Priority Dispatch Corp: **ProQA Mandatory Update Release Information**

Date: 13 April 11

Versions released: **v3.4.3.31**

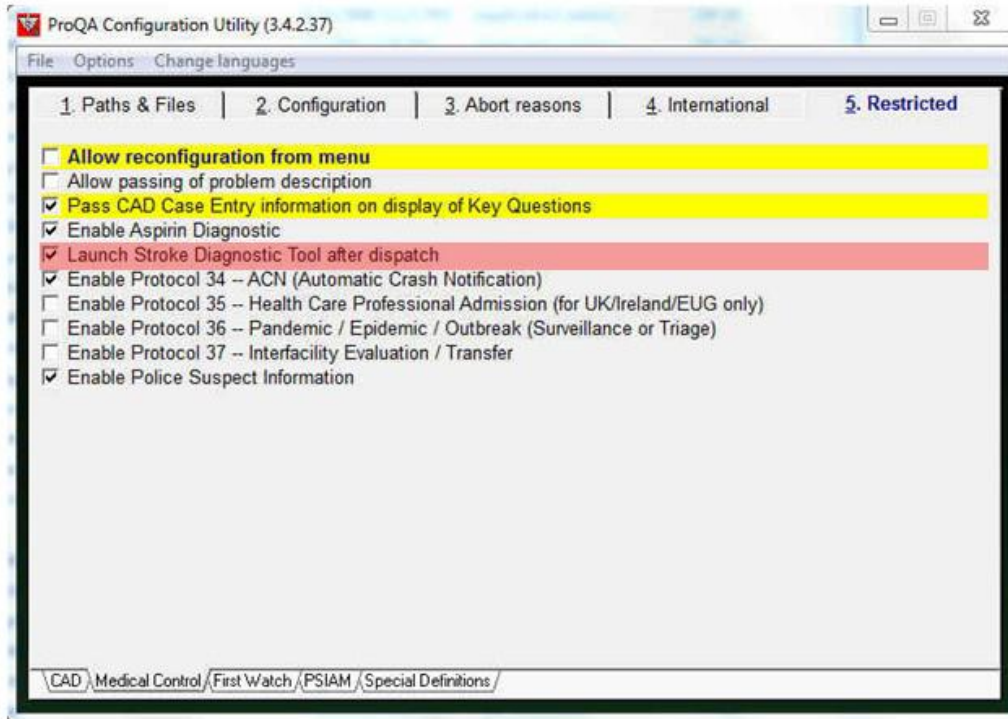
The Academy has added the ability to delay the launch of the Stroke Diagnostic Tool until after the dispatch point by selecting this option in the Administration Utility. Medical Director approval is required. (Proof #5630)

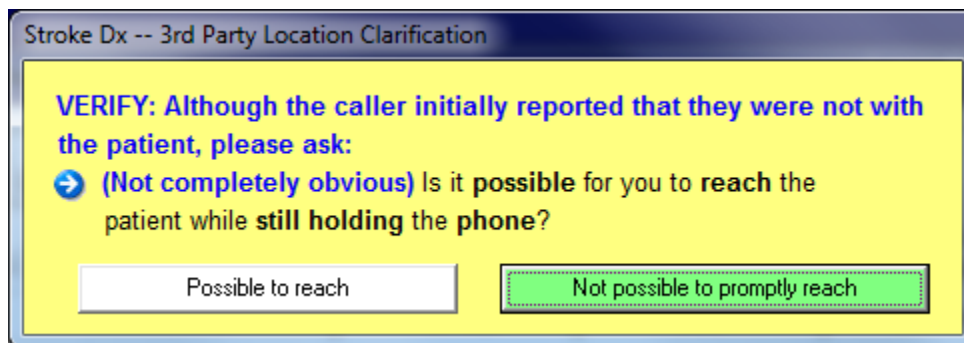
In conjunction with this feature, a 3rd party qualification directive has been added to determine the reasonable ability of the caller to get to the patient and apply the Stroke Diagnostic Tool when they have initially stated they are “not with the patient now.” (Proof #5710)

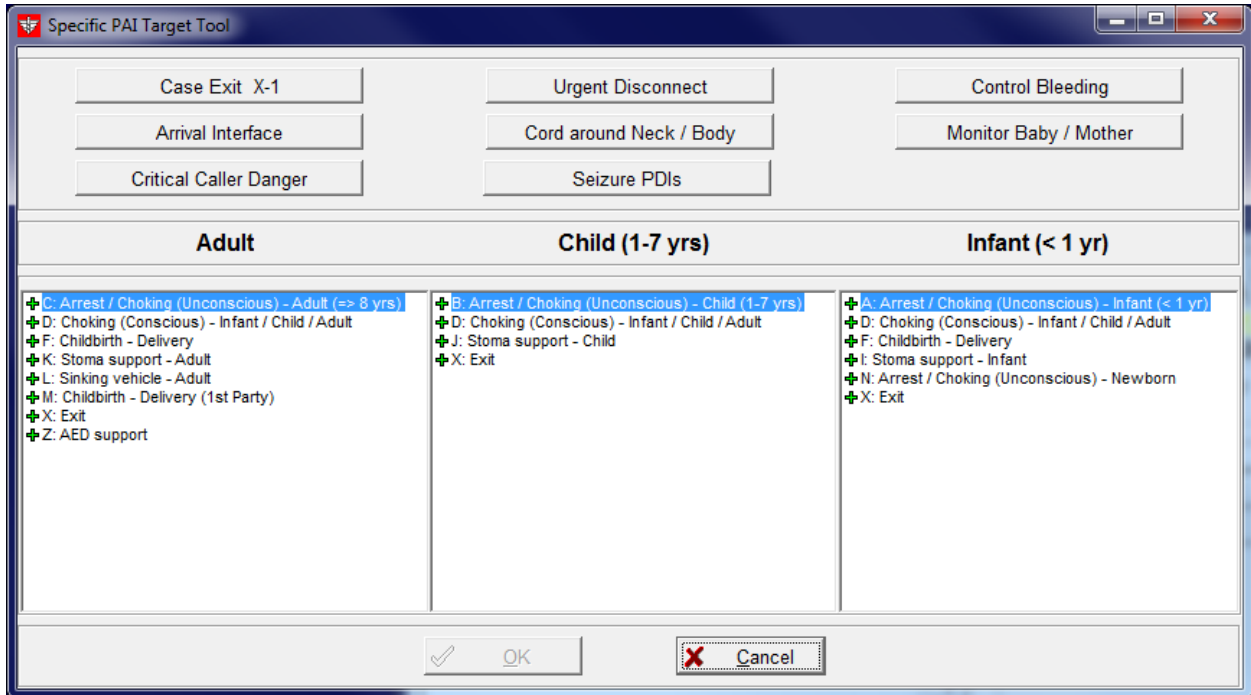
We have added a quick launch button within the "Target Tool" for accessing "Seizure PDIs" when using protocols other than Protocol 12 – Convulsion/Seizures/Fitting. (Proof #5577)
